State of New Mexico
 Energy, Minerals and Natural Resources

WELL API NO. 30-015-22779
5. Indicate Type of Lease STATE ☐ FEE ☒
6. State Oil & Gas Lease No. 311784
7. Lease Name or Unit Agreement Name Carter Gas Com
8. Well Number 1
9. OGRID Number 4323
10. Pool name or Wildcat Und. Morrow

SUNDRY NOTICES AND REPORTS ON WELLS (DO NOT USE THIS FORM FOR PROPOSALS TO DRILL OR TO DEEPEN OR PLUG BACK TO A DIFFERENT RESERVOIR. USE "APPLICATION FOR PERMIT" (FORM C-101) FOR SUCH PROPOSALS.)	
1. Type of Well: Oil Well ☐ Gas Well ☒ Other	
2. Name of Operator Chevron USA Inc	
3. Address of Operator 6301 Deauville Blvd Midland, Tx 79707	
4. Well Location Unit Letter <u>J</u> : 1980 feet from the <u>South</u> line and 1980 feet from the <u>East</u> line Section <u>18</u> Township <u>23-S</u> Range <u>28-E</u> NMPM County	
11. Elevation (Show whether DR, RKB, RT, GR, etc.) 3062.2GR

Operator: CHEVRON U S A INC 6301 Deauville Blvd Midland, TX 79706	OGRID: 4323
	Action Number: 395384
	Action Type: [C-103] NOI Plug & Abandon (C-103F)

CURRENT WELLBORE DIAGRAM

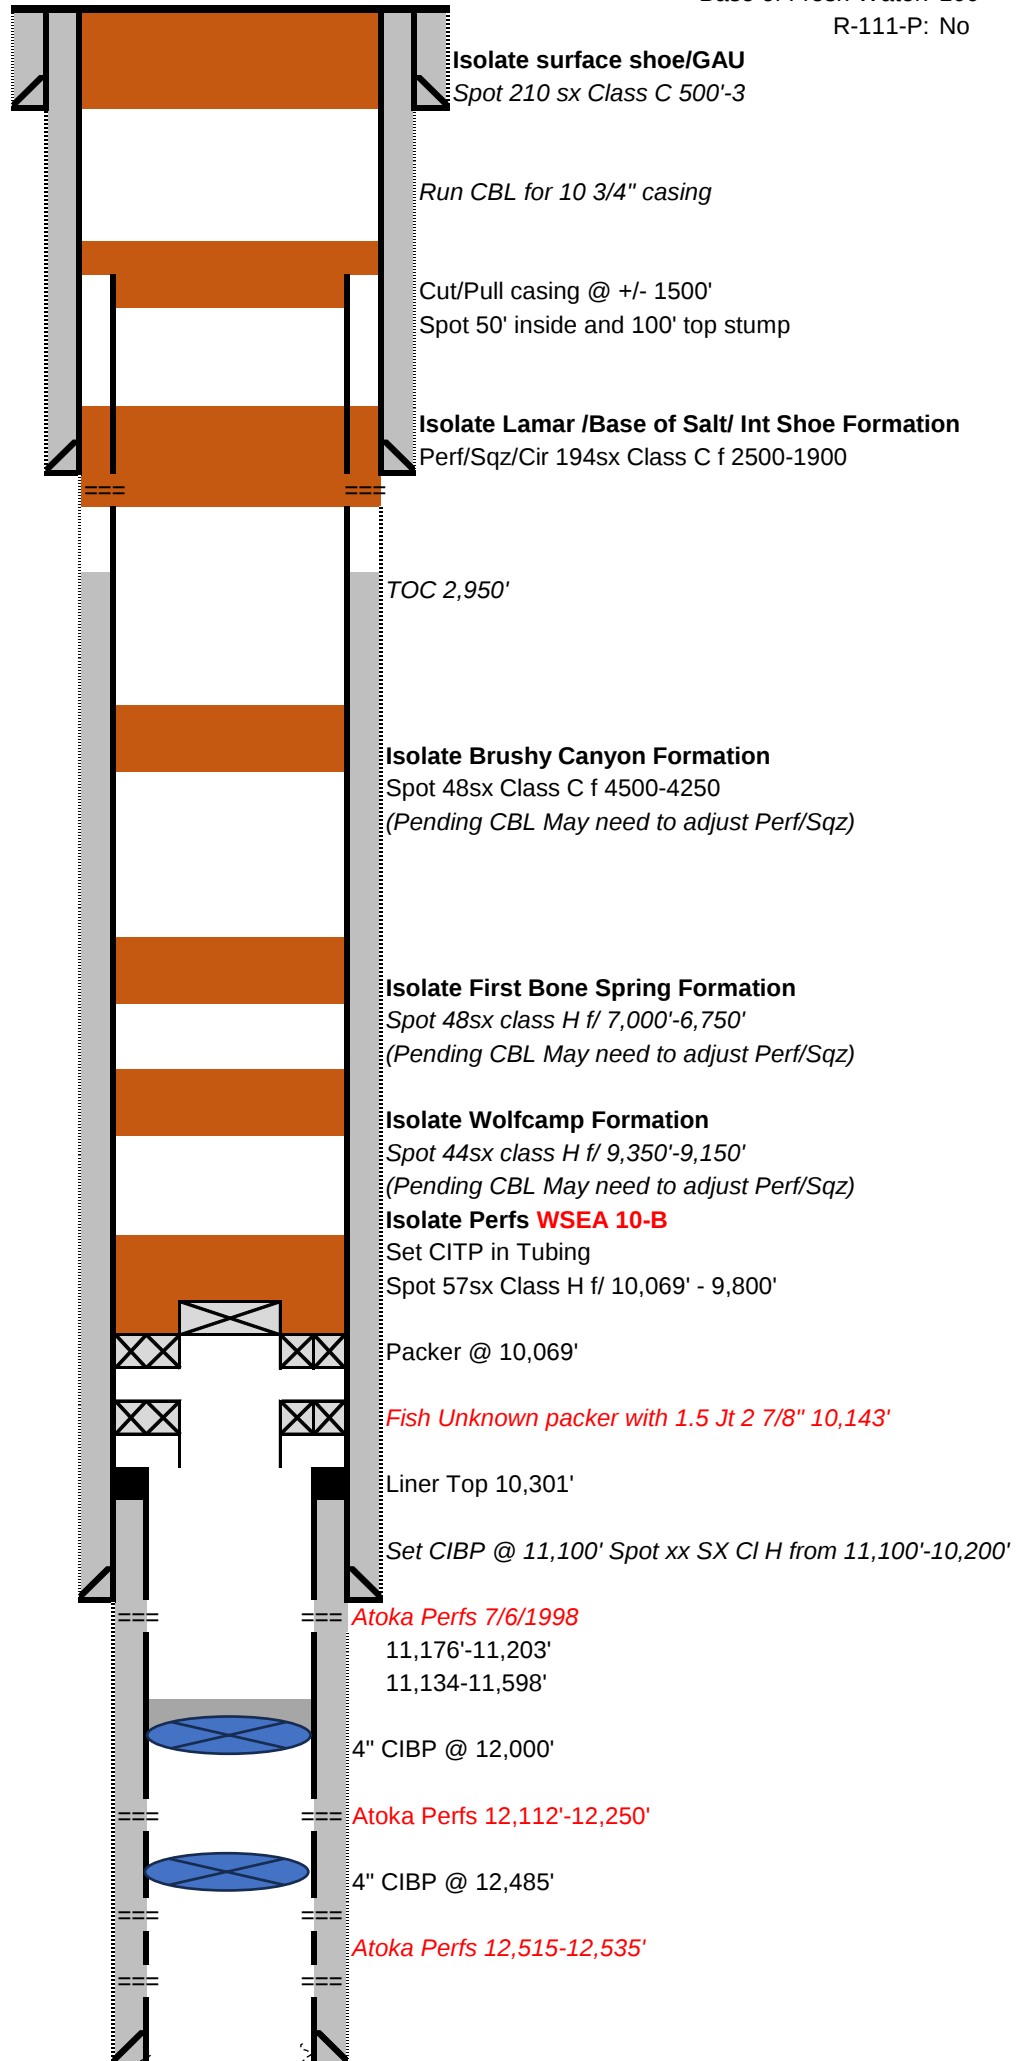
1. Clean out to ~11150'
2. Set CIBP @ 11125' - Test Casing 500psi/30min- Bubble Test - Run CBL in 4 1/2" csg to 10300' - 7 5/8" to Surface
3. Spot 15 sx cmt on CIBP - T Perforations & Strawn
4. Spot 25 sx cmt 10724' - 10550' - T Cisco & 7 5/8" shoe
5. Spot WCA plug Spot 44sx CI H 9,350'-9,150'. WOC/Tag
6. Spot First Bone Spring plug Spot 48sx Class H 7,000'-6750'
7. Spot Brushy Canyon spot 48sx Class C 4500'-4250'. WOC/Tag
8. Spot 48sx Class C 3300' - 3150'. WOC/Tag - Cherry Canyon
9. Perf @ 2500 to sqz/circ to isolate Intermediate shoe, Bell and lamar 194sx from 2550'-1900'. WOC/Tag -
10. Cut/Pull casing from 1500' and LD.
11. Pump stump plug 50' and 100' above stump. WOC/Tag/Test
12. Run CBL inside 10 3/4". Report back to engineer/NMOCD
13. Spot 230 sx Class c from 500-3.
